**TO:** Design Review Commission  
**FROM:** Sean K. Gallegos, Senior Planner  
**SUBJECT:** SC22-0007 – 1405 Highland View Court

Approve design review application SC22-0007 subject to the listed findings and conditions

SC22-0007 – 1405 Highland View Court

Figure 1: Front Elevation

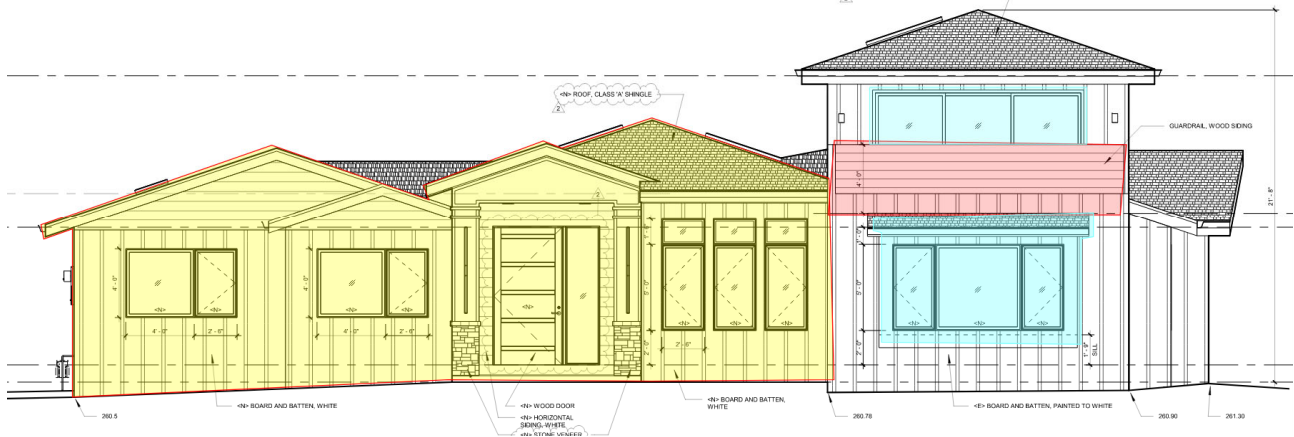
Overall, the existing front façade and exterior side elevations windows are similar in size and placement. However, the two second story windows along the front elevation are being replaced with a three-panel sliding door exiting from the office to a 200 square-foot balcony, and a large, fixed window on the first floor is being replaced with a substantially smaller window. Consistent with Sections 5.4 and 5.9 of the Residential Design Guidelines, the applicant has simplified window shapes along the front and exterior side elevations, which reduces the appearance of bulk and maintains cohesiveness with the plan composition.

Figure 2: Rear Elevation

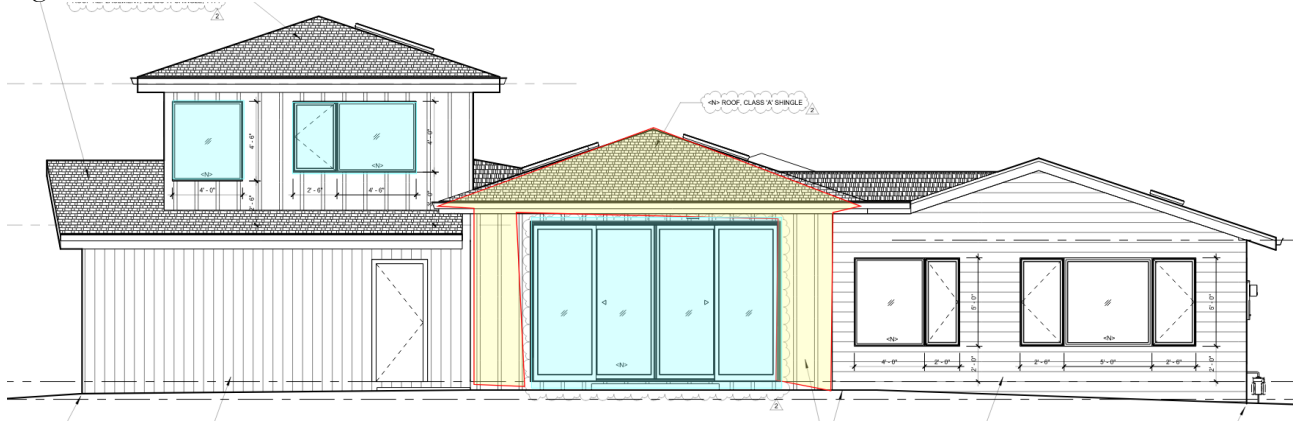
Currently, the existing rear (south) façade windows are larger in size and the sill heights have been lowered to create increased potential privacy impacts for neighboring properties. The proposed changes would incorporate a different window style/size with a degree of asymmetry. Staff is concerned with the proposal's consistency with Section 5.9 of the Residential Design Guidelines which speaks to locating windows where they visually relate to one another as part of a larger design composition, particularly as viewed from the street. Staff requests DRC direction on whether raising the sill heights and/or maintaining consistent window forms would create a more composed rear façade consistent with the Residential Design Guidelines.

The rear (south) façade windows are larger in size with a four feet wide by 4.5 feet tall window in a bathroom and a 7-foot wide by four-foot tall window in a bedroom, and the sill heights have been lowered to 2.5 feet and three feet, respectively. Staff has potential privacy concerns due to the number and lower sill heights of proposed windows on this elevation. Per page 14 of the Residential Design Guidelines, it is generally recommended that second floor side yard windows “should be no larger than UBC (Uniform Building Code) minimum sizes nor more than the number required for egress or light and ventilation requirements.” Per current standards, the minimum recommended sill height from staff to meet this guideline is 44 inches (3.6 feet). Therefore, staff proposes a condition of approval No. 2a that addresses the proposed sill heights to maintain Building Code standards.

- a. In order to mitigate privacy concerns resulting from the rear (south) second story windows, the applicants shall revise the second story windowsill heights to be no larger than UBC (Uniform Building Code) or other applicable Building Code's minimum sizes.

Figure 3: Exterior Side Elevation

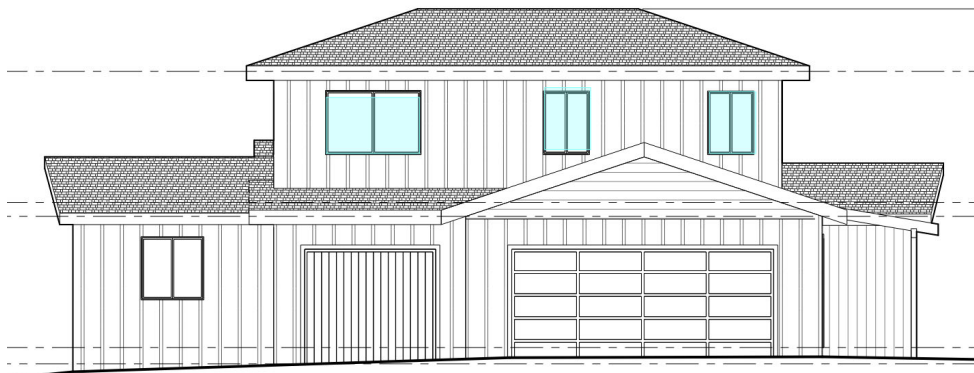
On the exterior side (north) elevation of the second story, there is a three-panel sliding door exiting from an office to a balcony. The balcony is 17 feet wide, has a depth of 11.75 feet and primarily faces the front and exterior side yards. The balcony size does not comply with the four-foot maximum balcony depth recommended in the Residential Design Guidelines, and it may be perceived to be active in nature due to its depth. However, Section 5.3 of the Residential Design Guidelines is intended to ensure privacy reduction for property owners along the interior side and rear property lines. The balcony is oriented toward two public rights-of-way, Highland View Court and Eva Avenue, which ensures privacy to adjoining properties along the interior side and rear property lines. Due to the balcony's views being oriented toward a public roadway and Section 5.3 of the Residential Design Guidelines, it is not intended to preserve privacy along a public roadway or along front yards. Staff believes the proposed balcony will not create any potential privacy impacts to the neighborhood context, including any active interior side yard or rear yards in the immediate neighborhood. As designed, staff finds that the project maintains a reasonable degree of privacy.
